Texas 2D BLE Analysis QA/QC Checklist

HUC-8 Watershed Name & ID:	Coyanosa (13070006) – COYA_006
HUC-10 Watershed Name & ID:	N/A
Modeler:	AtkinsRealis
Reviewer:	AECOM

M1 Review: Terrain, Modeling and Preliminary Tie-In Review (QC Items 1-6)

With terrain modification:**Without terrain modification (Raw terrain):**

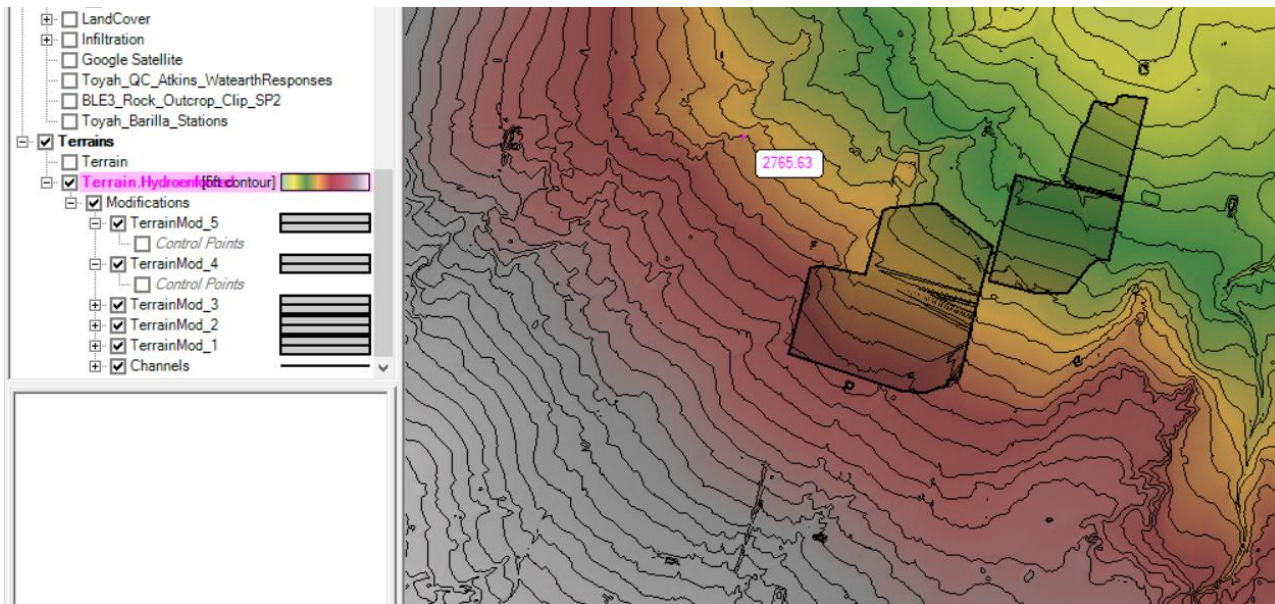
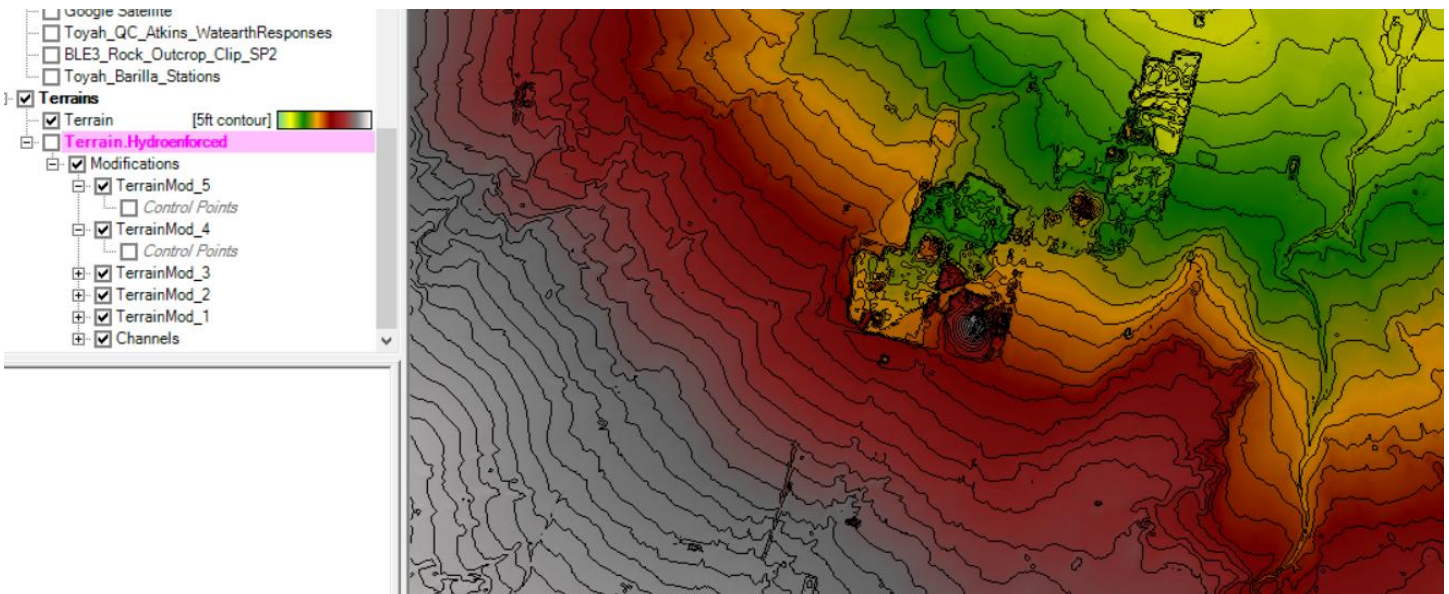
- I don't think the terrain modifications that are used for some depressions reflect the latest available data.
Watearth Response (08/05/2024): There were mining sites/borrow pits present in several of the model domains. The sites included large depressions that were typically 30 to 40 feet deep and up to one mile wide. In some instances, the sites were located near streams and had elevations lower than the stream channel's thalweg. The terrain modification polygons are used to adjust these elevations, and they are removing the mines and borrows from the actual terrain. Below the actual terrain and the terrain with modifications are shown for the same area from Toyah Watershed, which is one of the nearby ongoing watershed studies. This comment was discussed during the over the shoulder call on 07/25/24 between TWDB, AECOM and AtkinsRéalis and use of the terrain modifications accepted as reasonable.

AECOM Response (8/27/2024): PASS

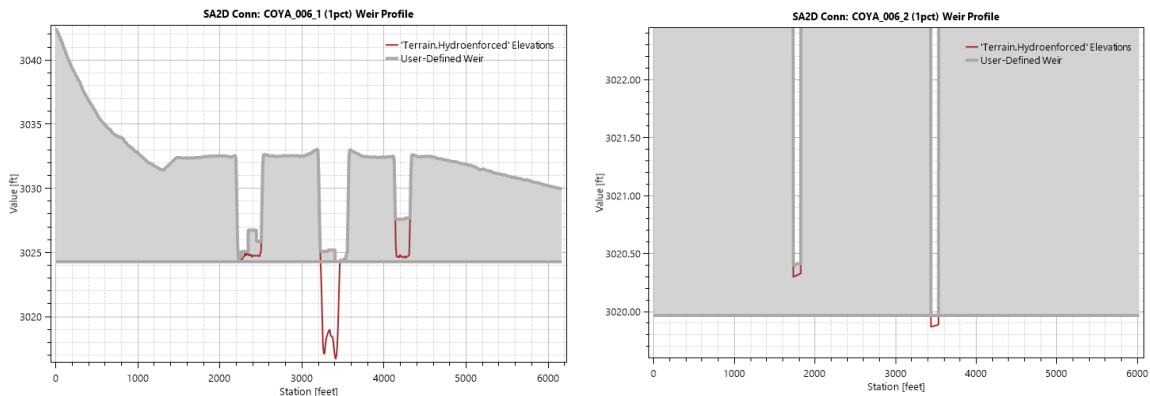
7. See QC shapefile for dams where breaklines weren't included.

Watearth Response (08/05/2024): Additional comments in the shapefile are addressed.

AECOM Response (8/27/2024): PASS

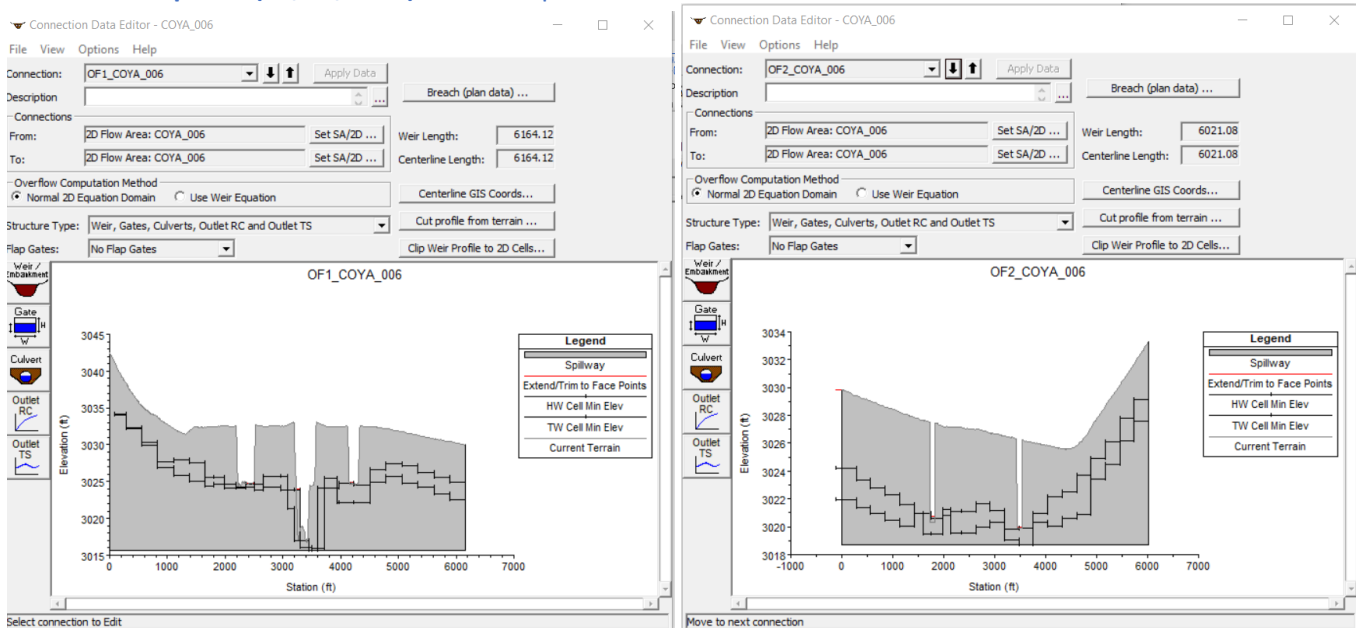
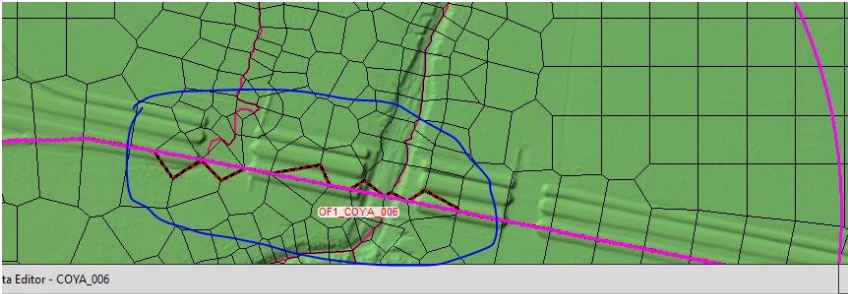
9. The two 2D connection weir profiles don't match the terrain. Please update the weir profiles so they match the terrain.

Watearth Response (06/05/2024): The weir profiles will be revised to match the terrain.

Watearth Response (06/24/2024): The weir profiles are as below:

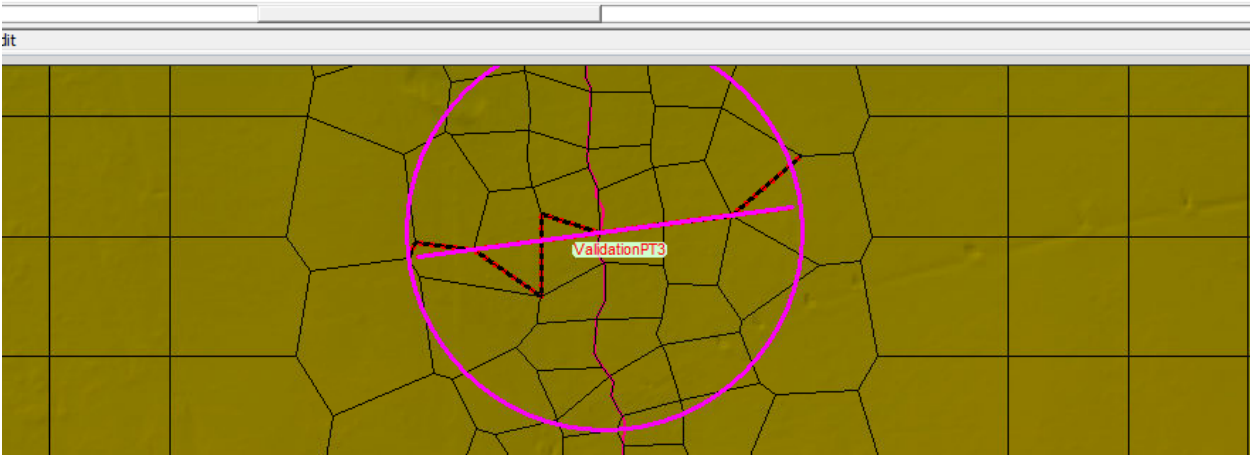
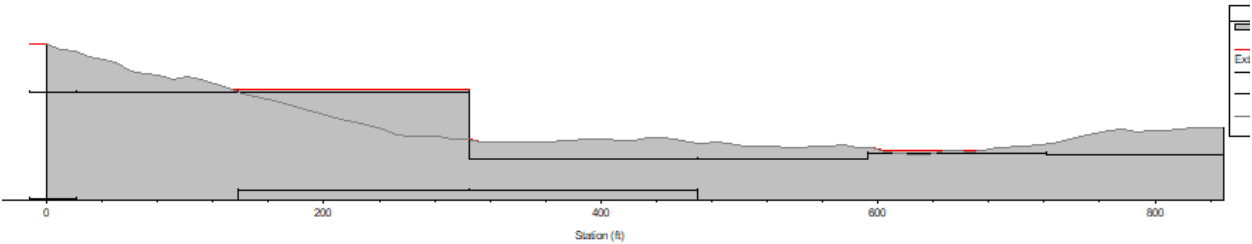
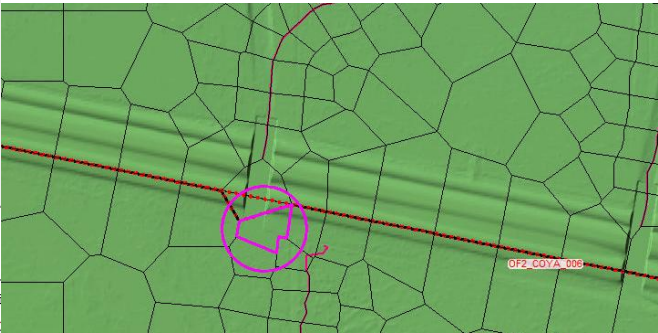
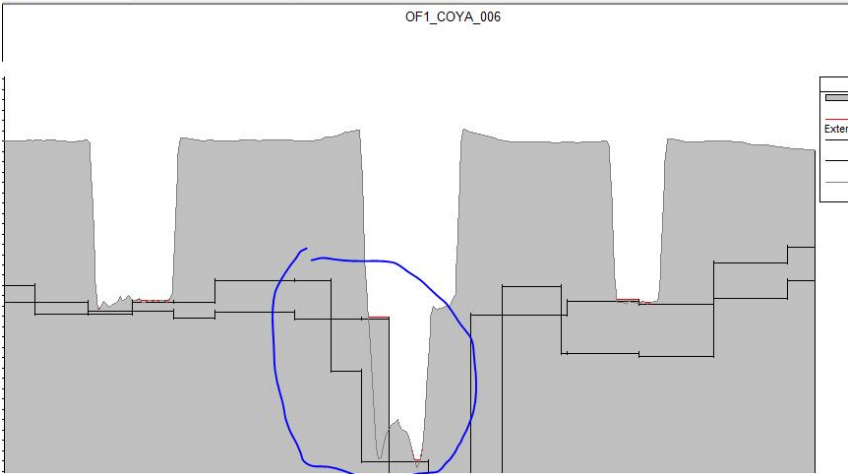
AECOM Response (7/25/2024): A significant portion of the middle channel is blocked I think because of the minimum cell elevations, and other 2D connections have a similar problem. This could be fixed by making sure cells are aligned to the 2D connection and then updating the weir profile. Please do this for every 2D connection.

Watearth Response (08/05/2024): As discussed during 07/25 call, all Sa/2D connections enforced and checked for any blocked channels are not blocked. All SA2D connections are enforced so that the cell alignments are good. Please see snips below:

AECOM Response (8/27/2024): PASS

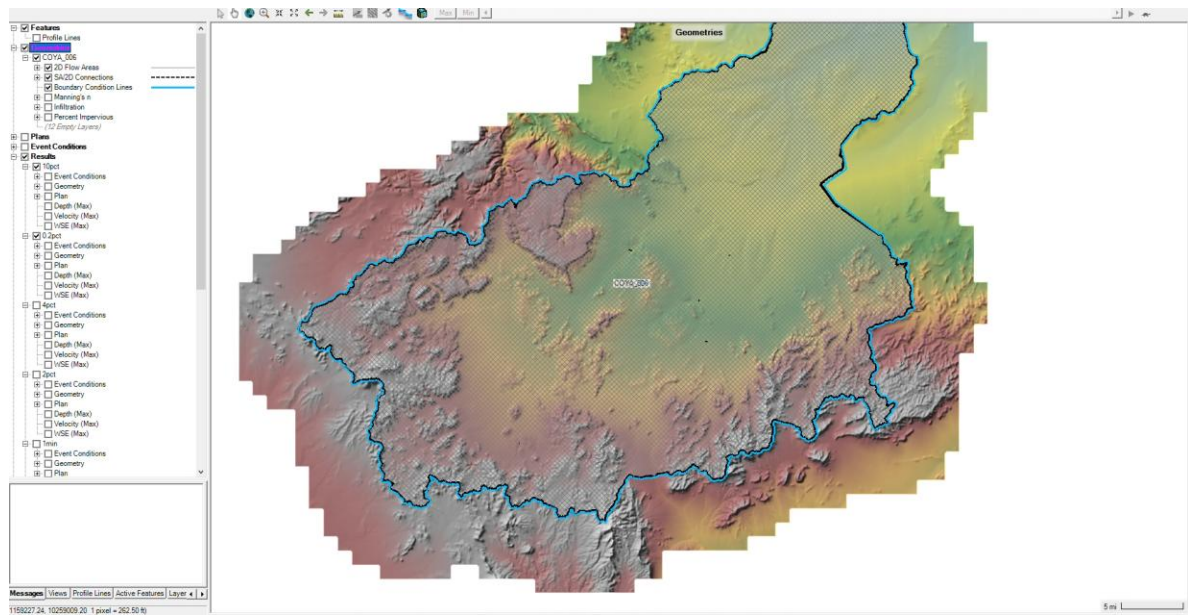
Note: "Mesh not created" in RAS Mapper and the Geometry Data shows that there are 40 cells with more than 8 sides. I think this might be because of cells aligning to the perimeter of refinement regions in RAS Mapper, but not in the Geometry Data. This is likely not a problem.

Response 20250331: Please open the model in RAS version 6.4.1. The model did not show any mesh errors when opened in 6.4.1. Please see screenshot below. As suggested in the comment the SA/2D connection was renamed to USGS08435660 in the model geometry and DSS. However in the results (.p.hdf) files previous name will appear as the model was not rerun.

Backcheck – PASS, RP

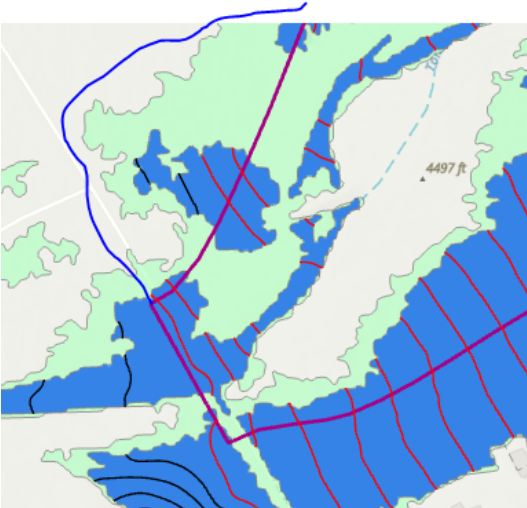
4. Adjustments should be made to the DTL_STUD_AR polygon. The polygon is meant to be bound the effective detailed study area polygons while also covering the floodplain boundaries from the BLE study that represents the flooding source. See bookmarks for an example and then review other locations. Blue line below is an example as well.

Response 20250331: Expanded DTL_STUD_AR to cover effective AE (and A#s), and BLE floodplains.

Backcheck – Approved, EDS
